FLIGHT READINESS STATEMENT
STS-95/ET-98
EXTERNAL TANK PROJECT
PRE-FLIGHT REVIEW

EXTERNAL TANK ET-98/STS-95, AS IDENTIFIED IN THE EXTERNAL TANK PROJECT PRE-FLIGHT REVIEW DATED SEPTEMBER 17, 1998, IS CONSIDERED READY TO SUPPORT FLIGHT UPON ACCEPTABLE DISPOSITION OF OPEN/PLANNED WORK AND/OR OPEN ACTIONS.

Space Shuttle External Tank

STS-95 ET-98 Pre-Flight Review

1871 Frame Outer Chord Extrusion

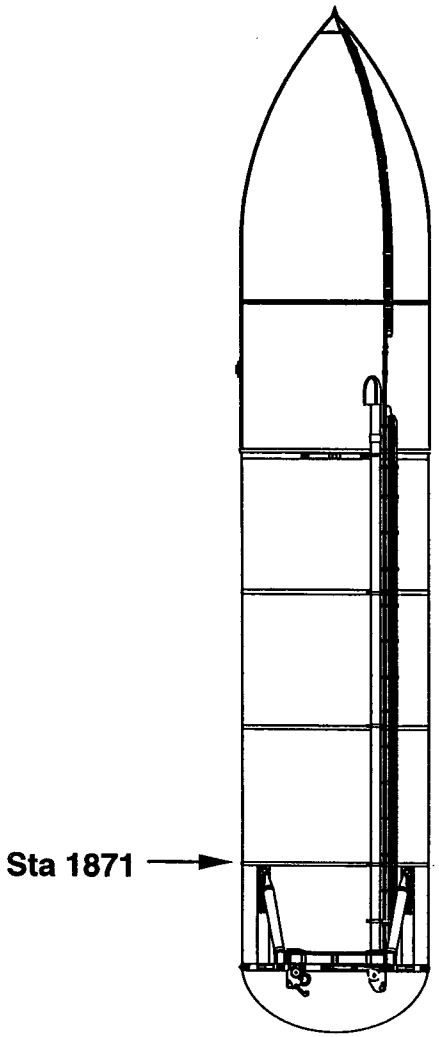
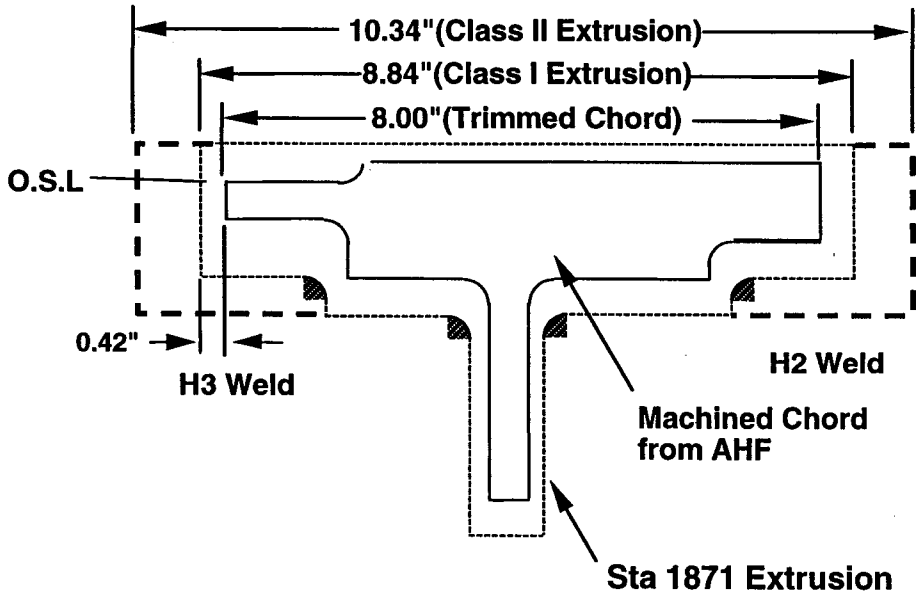
B) ADD ET11 BASIS IS SIMILITUDE
ET 14/21 ADD PROOF TEST REQT (F.M. 71.0)
ET 18/19 REFLECT REDESIGN WAS TO REDUCE SCRAP TO TO CRACKS DURING FORMING
ET 23 CLARIFY 2219 FRAMES
ET 27 CLARIFY F.S. ON CLASS II

Clarify
